DATE: 03/24/08
SEAL: [Professional Seal]
PROJECT NAME: WEST BLVD & CLANTON RD REZONING
SHEET TITLE: TECHNICAL DATA SHEET
FOR PUBLIC HEARING
PETITION 2008-
SHEET NUMBER: RZ-2
DRAWN BY: LINA
DATE: 03/24/08
SEAL: [Professional Seal]
PROJECT NAME: WEST BLVD & CLANTON RD REZONING
SHEET TITLE: TECHNICAL DATA SHEET
FOR PUBLIC HEARING
PETITION 2008-
SHEET NUMBER: RZ-2
DRAWN BY: LINA

DATE: April 4, 2008
TO: Gary Huss, Zoning Supervisor
FROM: Debra Campbell, Planning Director
SUBJECT: Administrative Approval for Petition No. 2007-134, Charlotte Housing Authority.

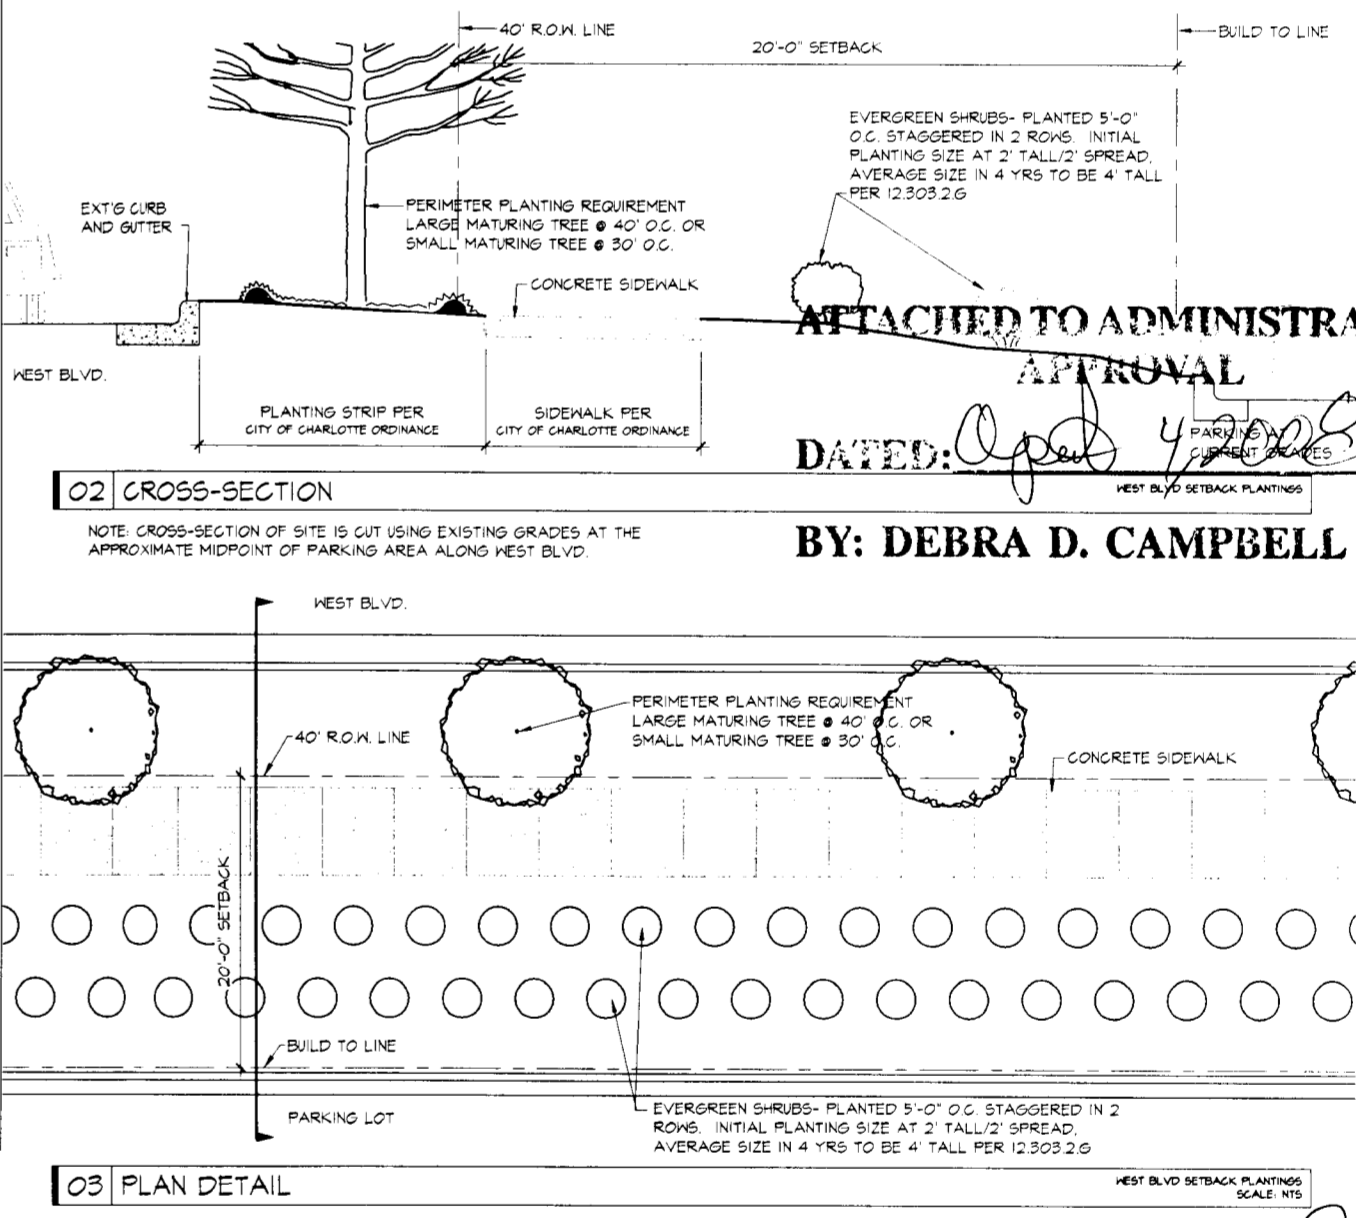
Attached are revised plans for the above petition. The plan has been revised to expand the first floor of the childcare center from 22,000 square feet to 25,000 square feet and incorporate building elevations. The present plan is approved for a two-story childcare facility with up to 32,000 square feet, which will not change. Since these changes do not alter the intent of the development and meet the requirements of the Charlotte Zoning Ordinance Section 6.207 Alterations to Approval, minor changes, I am administratively approving these plans. Please use these plans when evaluating requests for building permits and certificates of occupancy.
